CHILDREN'S HOSPITAL
OF ORANGE COUNTY

TOWER II

LOWER LEVEL MECHANICAL
PLAN AREA - K

M3.0K

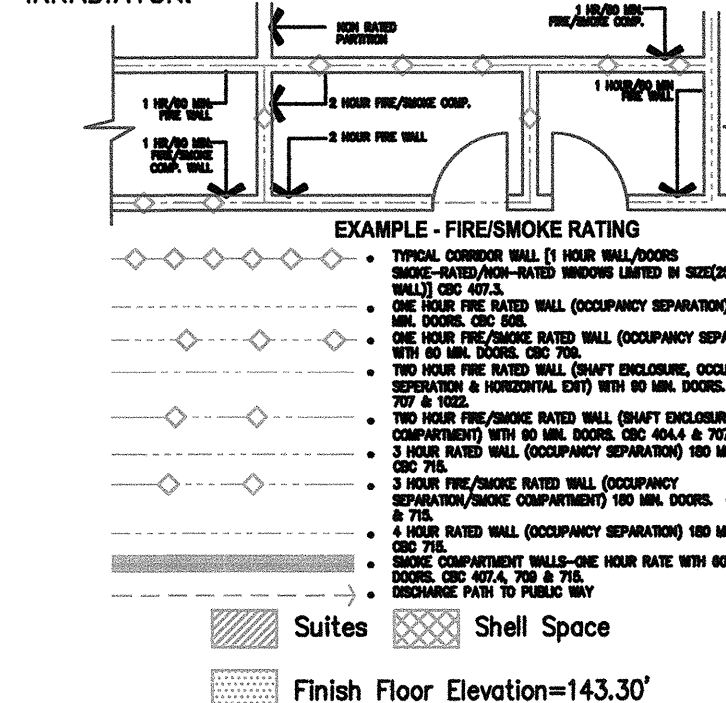
09/27/2010 CHANGE ORDER #75
02/24/2011 CHANGE ORDER #141

CHANGE ORDER #141
INSTRUCTION BULLETIN
REVISION APPROVAL
APPENDIX
